ADDENDUM NUMBER: **1**

May 21, 2018

Texas A&M Aerothermochemistry Lab Expansion
1733 George Bush Drive W, College Station, TX 77845

Prozign Project No: 1605 PM:
SSC Project No. 2017-02079

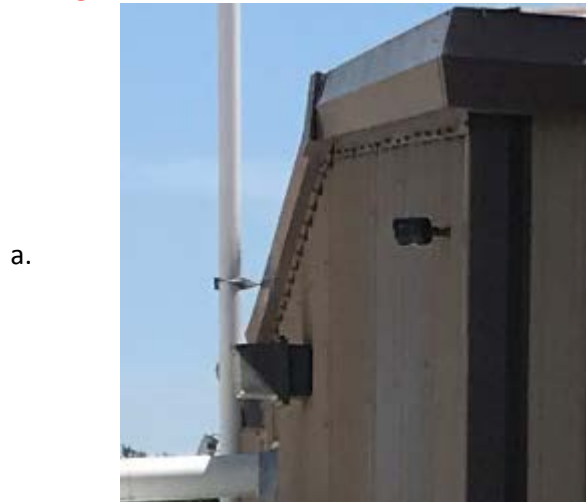
28. T3.01 calls for the security cameras noted to be owner furnished contractor installed. Please verify that this "contractor" is the owner's security contractor and outside the scope of this project.

☐	SECURITY CAMERA LOCATION. PROVIDE (1) DATA DROP AT EACH LOCATION. CAMERA IS OWNER FURNISHED, CONTRACTOR INSTALLED.
☐	EXTERIOR SECURITY CAMERA LOCATION. PROVIDE CONDUIT, BACK BOX, AND (1) DATA DROP TO PLENUM SPACE ABOVE ACCESSIBLE CEILING. CAMERA IS OWNER FURNISHED, CONTRACTOR INSTALLED.

Response: Drawings revised

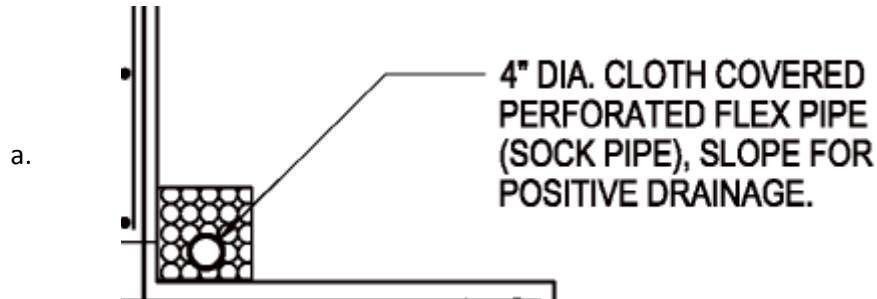
29. A2.02 Finish schedule labels Room 212 as "Janitor" Please verify that this should be labeled "Restroom" and confirm finishes listed are correct. **Response: Drawings have been revised**
30. 02/A5.11 note 48; The shown soffit/overhang for the existing metal building does not match the existing site condition, there is no soffit, just a standard PEMB fascia on the North side of the existing building. Please confirm that this detail still applies, if not please provide new detail for the tie-in to the existing building. See below pic. **Response: Drawings revised**

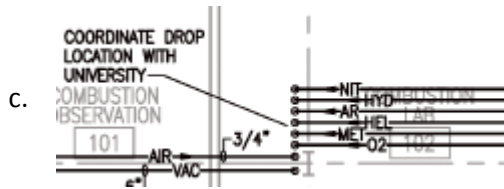
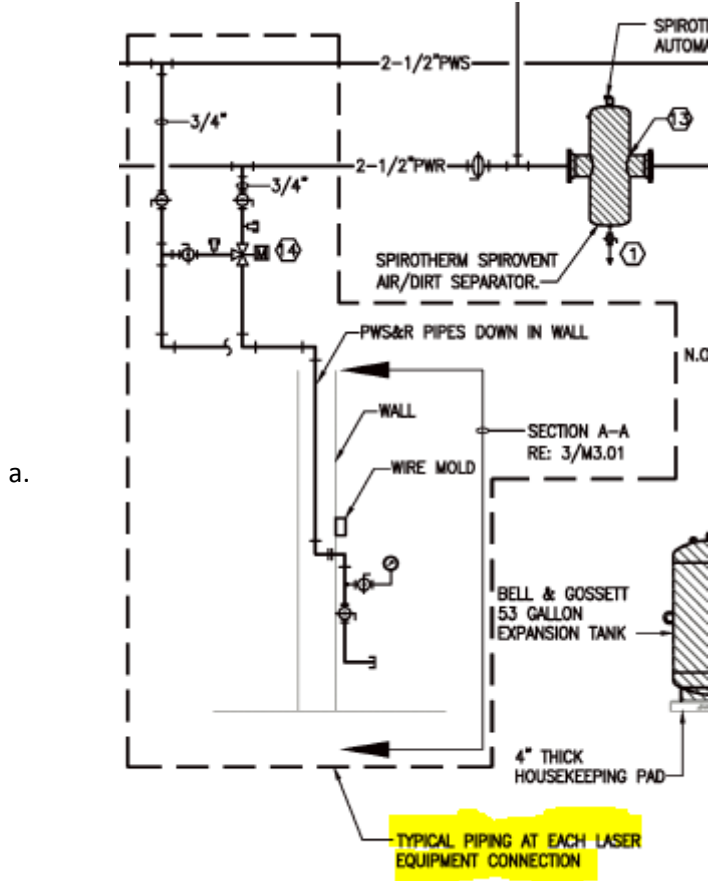
41. Key note 11 (TYP) on M1.01 for process water down in wall occurs 16 times. The detail 1/M3.01 calls for process water in wall at each laser equipment connection. Please verify that this is correct as 1/P3.01 calls for only 5ea lab gas drops in the Miles Lab 103 and 1ea lab gas drop in the Combustion Lab 102 ("one at each laser"). Please verify.

Response: Per email from Architect on February 27, 2018 Plumbing Drawings are correct as shown (five drops in Miles Lab 103, one in Combustion Lab 102, and one in Lab 3, Room 211. All drop locations to be coordinated with University.

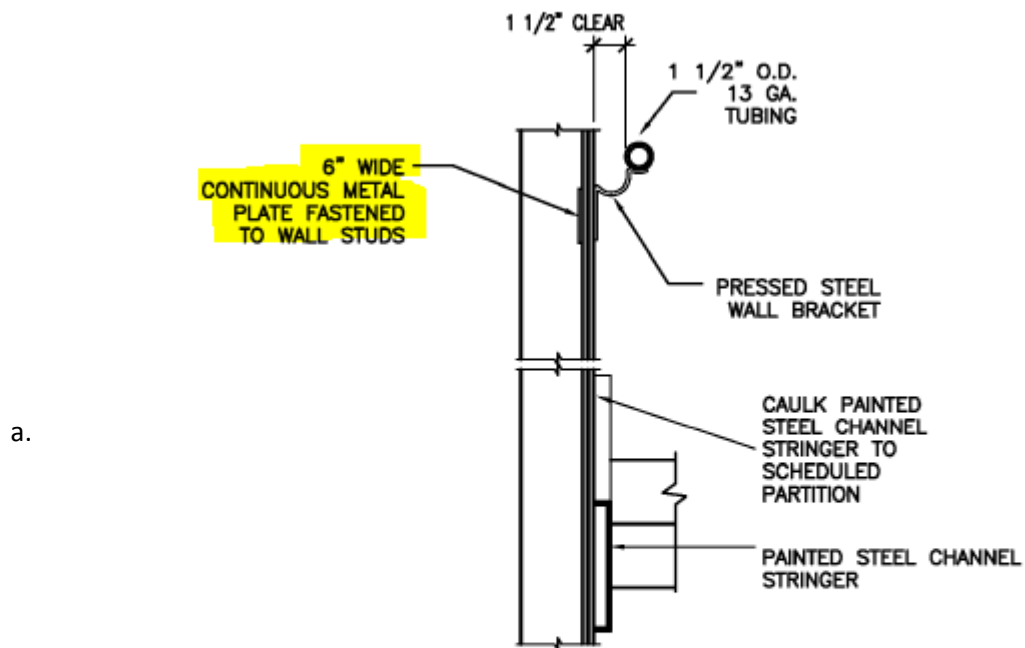
50. Please verify that the following items locates at GL 5.4/D are to be part of the Lab Shell Space Alternate #3.

Response: Items are a part of Lab Shell Space Alternate #3
